IDAP REPORT

Property:	31 Augusta Street, Strathfield Lot 14 DP 12824 DA2021/66
Proposal:	Demolition of existing structures and construction of two (2) storey dwelling house with basement level, in-ground swimming pool, outbuilding, front fencing and associated landscaping works.
Applicant:	H.A Design Group
Owner:	V Maniam
Date of lodgement:	23 April 2021
Notification period:	03 May 2021 to 17 May 2021
Submission/s received:	One (1)
Assessment officer:	P Santos
Estimated cost of works:	\$1,456,340.00
Zoning:	R2-Low Density Residential - SLEP 2012
Heritage:	N/A
Flood affected:	Yes
RECOMMENDATION OF OFFICER:	APPROVAL

Figure 2. Extract of the most recent site plan, received by Council on 15 July 2021.

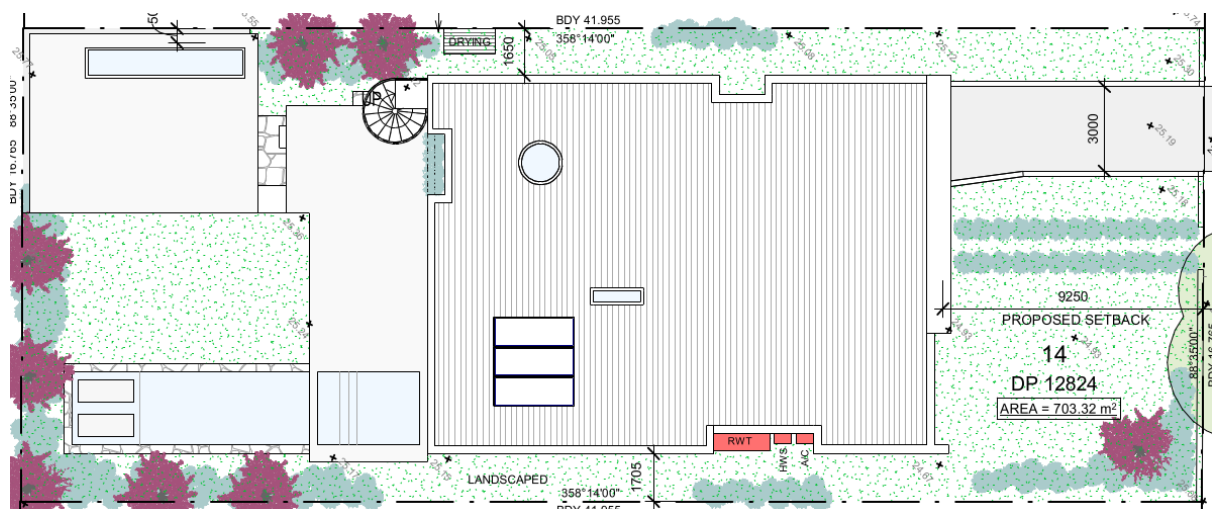
The proposed development includes a swimming pool located at the rear of the dwelling house. Several trees currently exist within the rear yard of the site as shown previously in Figure 15 and Figure 17 below.

The proposed in-ground swimming pool will require excavation. The excavation is believed to be in close proximity to the mentioned trees. With the absence of documentation and information in relation with the trees, Council cannot make a determination whether the removal of the trees is supportable or the trees need retaining. In this case, there is also lack of information whether the trees, due to the pool's closeness, can withstand the proposed excavation.

In this regard, the swimming pool cannot be supported. For completeness, a condition of consent will be imposed to delete the swimming pool prior to receipt of the construction certificate and the removal of the trees and the swimming pool be lodged as a future application.

- a) not permit any removal of any trees on the site without appropriate consent, and
- b) the swimming pool to be deleted from the plans and must be reflected in the documentation prior to the receipt of a construction certificate.

Figure 4. Extract of the most recent proposed ground floor plan, received by Council on 15 July 2021.

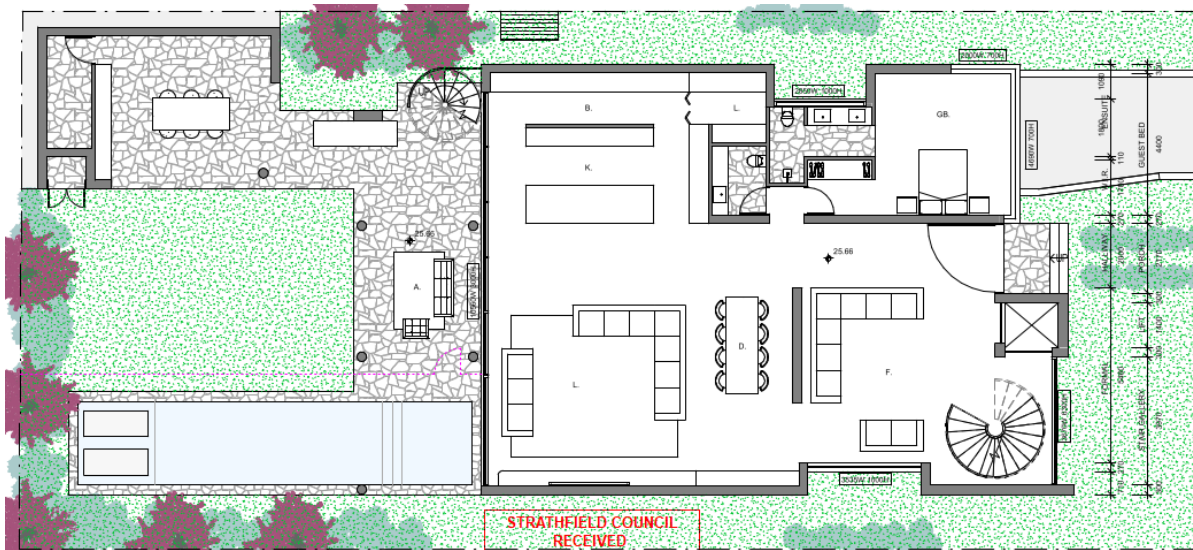
A concern was raised regarding the potential water runoff to neighbouring properties. In particular, the impact of the proposed hard surface area between the outbuilding and the side and rear boundaries, shown as hard surface areas on the plans (See Figure 4).

Naturally, gravity impacts the flow of water. In the survey plans provided to Council, no information has been provided regarding the levels of the adjoining properties. Council will not support water runoff going to neighbouring properties. As such, due to the absence of the levels information on the survey plan of the neighbouring properties, a condition of consent will be imposed to delete any hard surface areas to the north and east of the outbuilding to allow the ground to absorb any water runoff.

Figure 16. Extract of the initial basement design proposed, dated 07/03/2020.

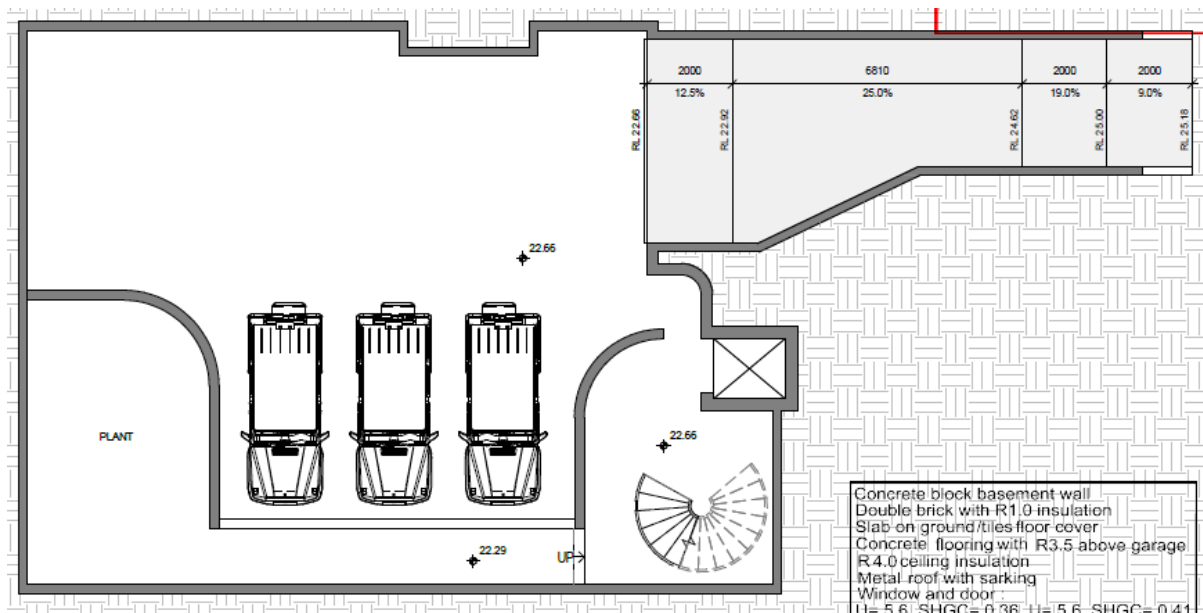
"Council's CDCP Part A Clause 8.1 requires excavation to be minimised to reduce disturbance to natural ground level. The proposed basement includes an excessive blind aisle extension beyond the last car space. The swept paths adopted B99 vehicles instead of the typical B85 design vehicles and hence indicates a larger area required for vehicle manoeuvres. It appears to be possible to reduce the basement area whilst still maintain adequate vehicle manoeuvres."

The comments above was for the initial design proposed for the basement (Figure 16 below). The basement was amended since and Figure 3 shows the most recent basement design, which is acceptable.

Figure 18. Extract of the initial Site Analysis Plan, dated 07/03/2020.

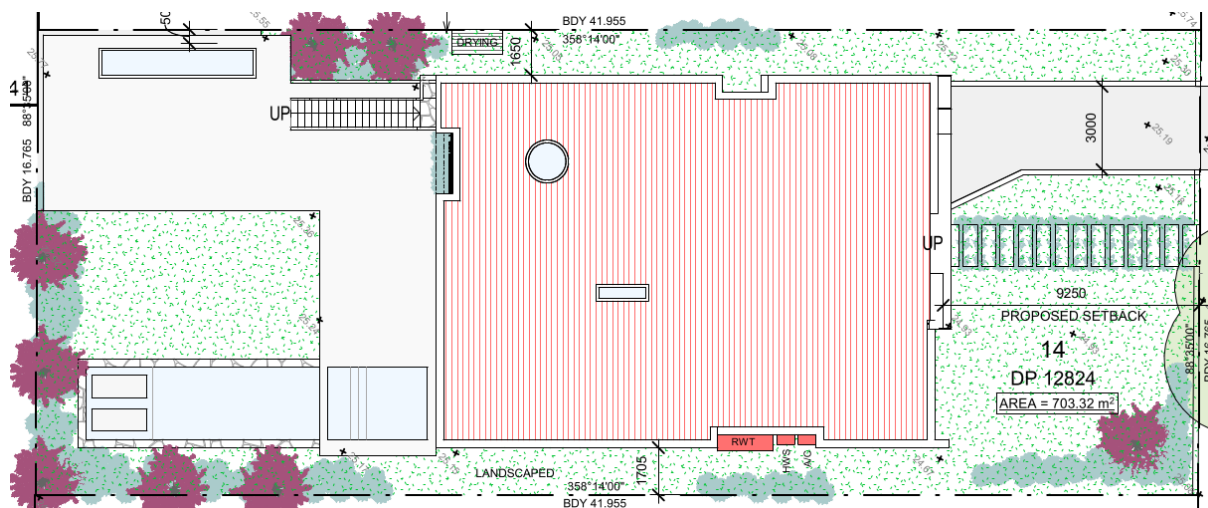
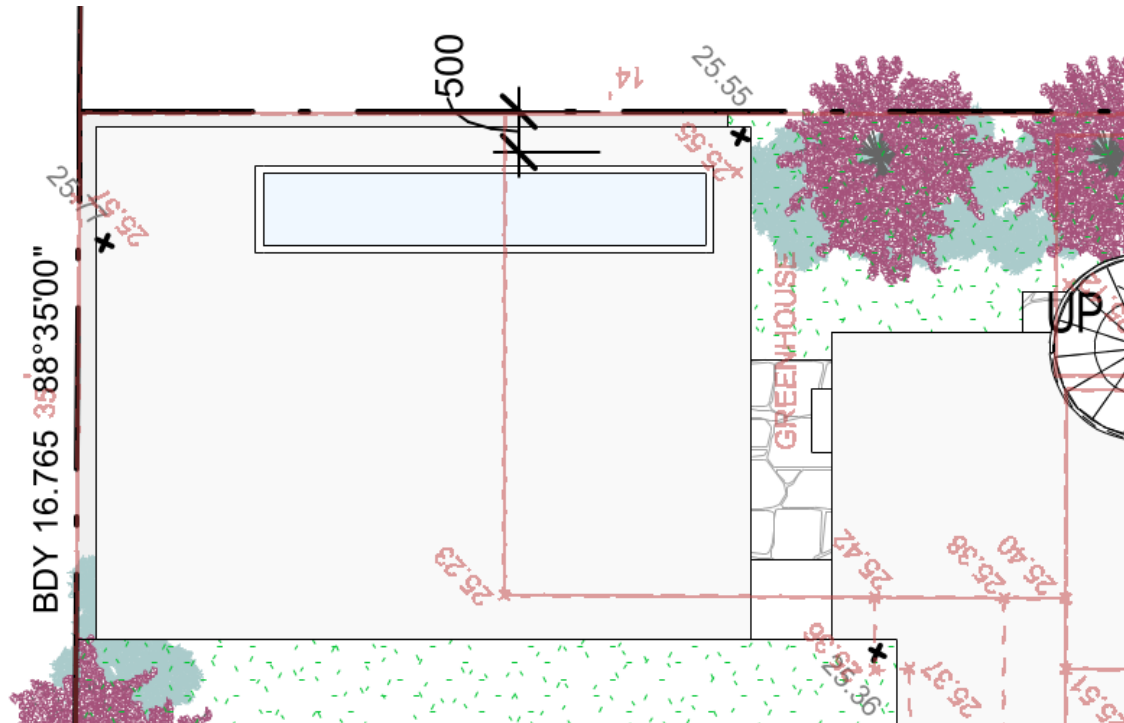
A concern was raised regarding the extensive built-form proposed towards the rear of the site. In particular, the outdoor area that extends up to 0.5m before the rear boundary.

Figure 18 above shows that the roof of the attached outdoor area goes all the way to the rear. This is not supportable as the cabana or the pool house, as what the plans refer it to, located at the north-eastern corner will not be considered an outbuilding but part of the dwelling house. As such, should have applied the dwelling house rear and side setback requirements, which are 6m from the rear and part of the 20% combined side setback.

The plans were amended and separated the outbuilding from the dwelling house. In this regard, the outbuilding satisfies the outbuilding setback requirement of 0.5m of the SCDGP 2005. However, failed to satisfy the height requirement of no more than 3.5m. For completeness, Figure 19 below shows the survey plan overlaid on the most recent site plan.

The highest point of the roof of the outbuilding has an RL 29.16, as per the elevations plans. This means that the height of the outbuilding is more than 3.5m. For clarification, the proposed outbuilding height is 3.93m. This is not supportable as it presents an unreasonable bulky built-form when viewed from eastern neighbour, exacerbated by the attached roof that has a height of RL29.16 covering the alfresco and the barbecue.

Figure 20: Extract of the first survey plan (top) submitted to Council and the most recent survey plan (bottom) sent as a response to the additional information request by Council.

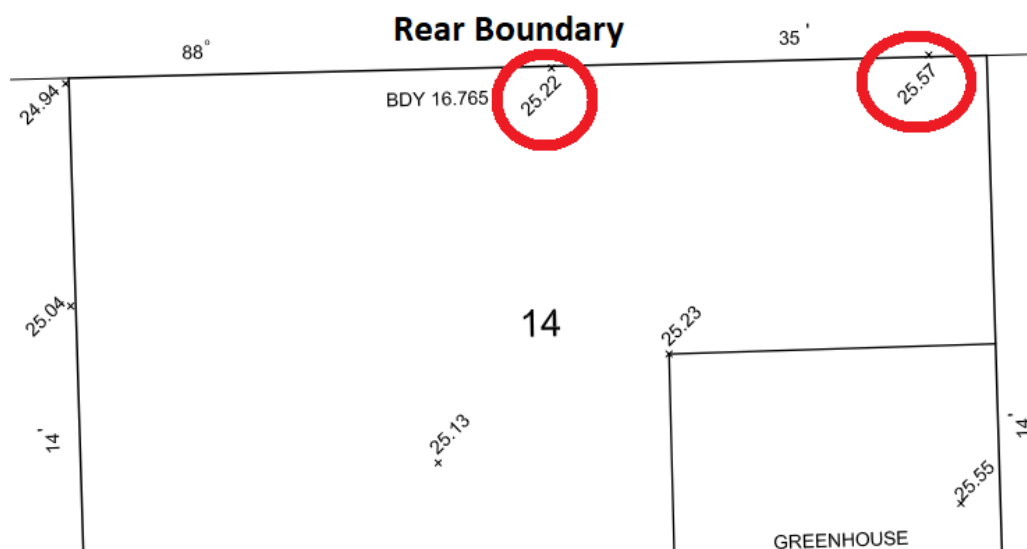
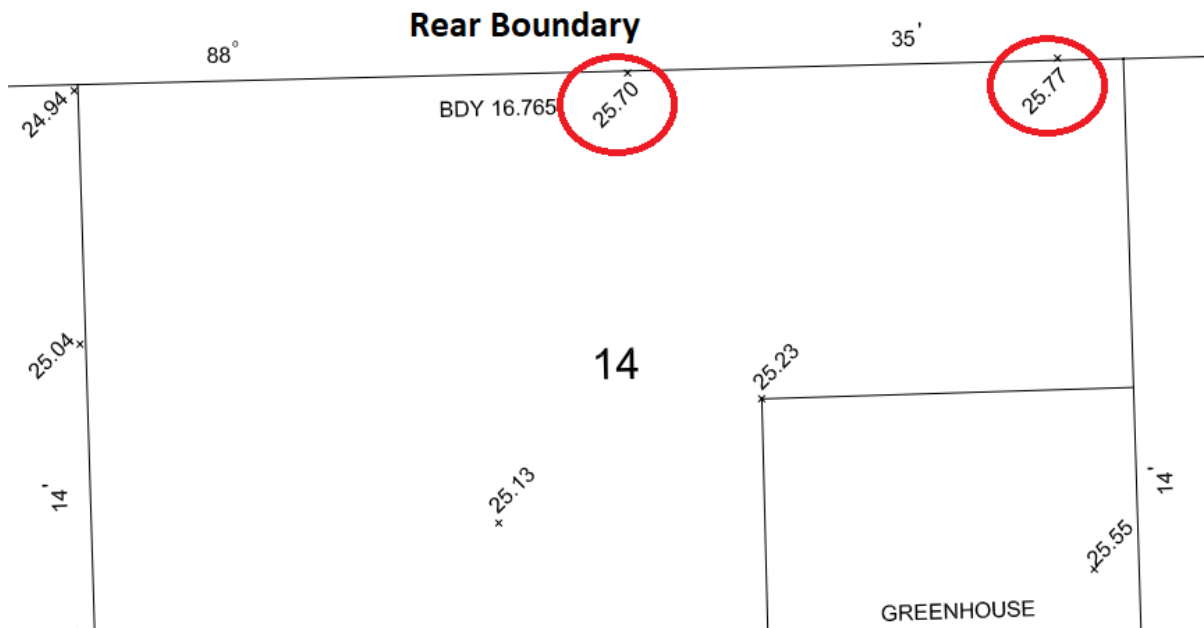
A concern was raised regarding the levels indicated on the survey plan. Note that the survey plan initially submitted to Council did not contain information of the registered surveyor who prepared the document. This concern was raised in the additional information letter, dated 18 June 2021, where information regarding the existing trees were also requested.

The discrepancy was that the initially submitted survey plan had RLs 25.70 and 25.77 at the rear of the subject site, where it is close to the proposed outbuilding. The most recent survey plan has the levels RL 25.22 and 25.57.

The applicant provided the amended survey with the suitably qualified surveyor's information. However, the levels at the rear of the property had changed. Figure 20 below shows the noticeable discrepancy between the two surveys provided to Council.

Figure 21. Extract of the Front Fence Elevation Plan showing the original fence design, dated 07/03/2020.

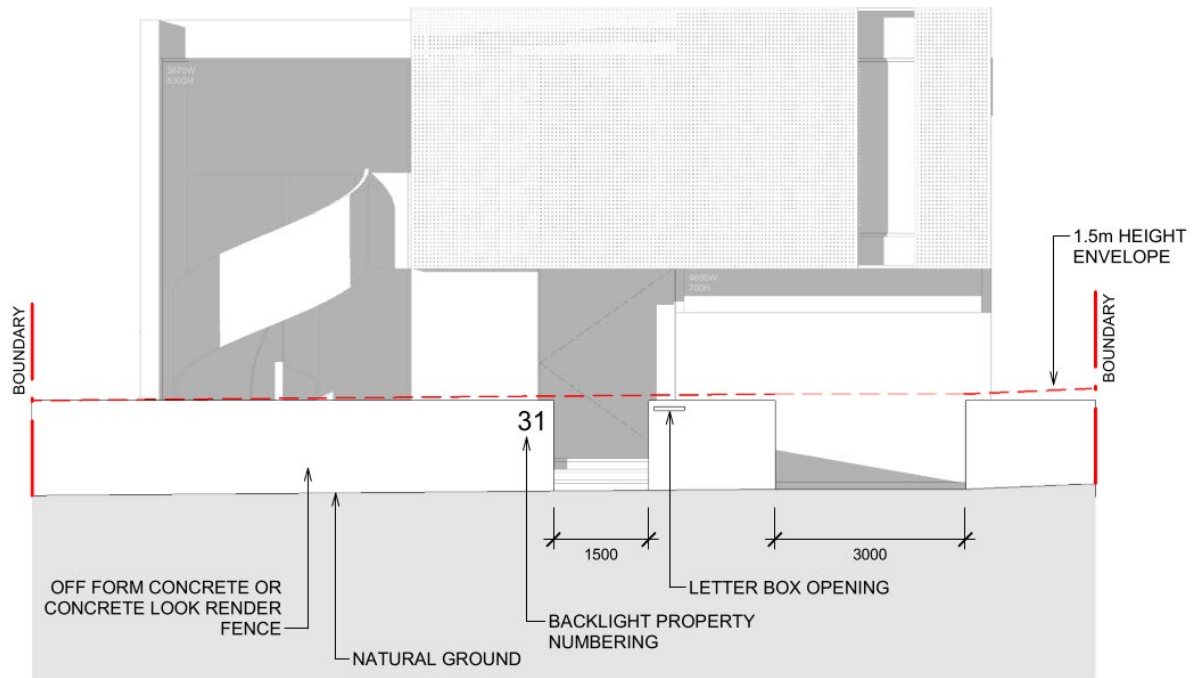
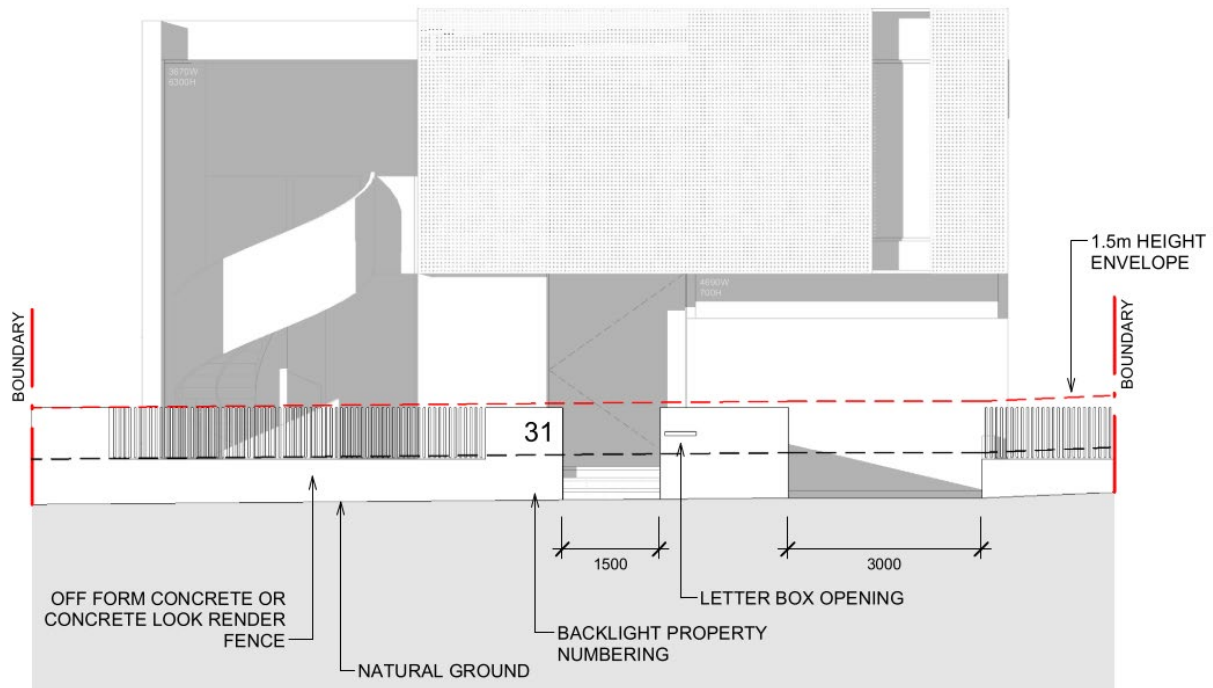
A concern was raised regarding the height of the proposed front fence. The proposal initially had a full solid front fence. This was not supportable as relayed to the applicant via the additional information request letter. The design was changed to a more suitable design, compliant with the requirements of the SCDCP 2005.
